Access Compliance Report

Public Rights-of-Way

(Curb Ramps)

Intersection ID: 27315	Main Street: ELM_LN	Cross Street: BALLANTYNE_TRACE_CT	Location: SW
ADA ID: F625AE7A453B	Ramp Type: BlendTrans2	Initial Pass/Fail: Fail	Overall Compliance: No
Severity Score: 10			
Codes/Mitigation Info/Possible Solution		Field Measurements/Component Compliance

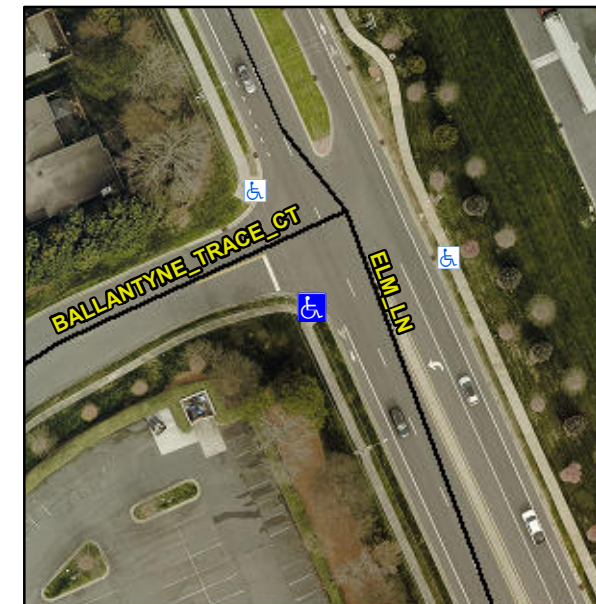
Not Found, R304.5.1, R304.5.3

Compliance	Description	Data	Compliance	Description	Data
N/A	Ramp Length (in)	97.0	Yes	BlendTrans Slope (%)	4.2
No	Ramp Width (in)	43.5	No	BlendTrans XSlope (%)	2.9
N/A	Flare Type LT	N/A	N/A	Flare Type RT	N/A
N/A	Flare Slope LT (%)	N/A	N/A	Flare Slope RT (%)	N/A
N/A	Flare Traversable LT?	N/A	N/A	Flare Traversable RT?	N/A
N/A	Landing Length (in)	N/A	N/A	DWS Provided?	N/A
N/A	Landing Width (in)	N/A	N/A	DWS Contrast?	N/A
N/A	Landing Slope (%)	N/A	N/A	DWS Length (in)	N/A
N/A	Landing X Slope (%)	N/A	N/A	DWS Full Width?	N/A
N/A	Landing Curb? (Y/N)	N/A	N/A	DWS Offset (in)	N/A
N/A	Shared Landing?	N/A			
N/A	Gutter Ponding?	N/A	N/A	Gutter Slope (%)	N/A
N/A	Gutter Lip Ht (in)	N/A	N/A	Gutter X Slope (%)	N/A
N/A	Painted X Walk1?	No	N/A	Painted X Walk2?	No
	X Walk 1 Direction	To NE		X Walk 2 Direction	To NW
	X Walk 1 Width (in)	N/A		X Walk 2 Width (in)	N/A
	X Walk 1 Slope (%)	0.8		X Walk 2 Slope (%)	1.8
	X Walk 1 X Slope (%)	0.5		X Walk 2 X Slope (%)	5.0

N/A	Ramp inside XWalk1?	N/A	N/A	Ramp inside XWalk2?	N/A
	Road Slope (%)	3.7		Clear Space?	N/A
	Road X Slope (%)	0.7	N/A	Clear Space to XWalk (in)	N/A
N/A	Any Obstructions?	N/A	N/A	Storm Grate/Utility Hazard?	N/A
	Obstruction Type			Storm Grate/Utility Type	
		N/A			N/A
			Yes	Surface Condition? (G/P)	Good
			No	Curb Slope (%)	22.4

Remove & Replace Curb Ramp With Two New Directional Ramps or Equivalent.
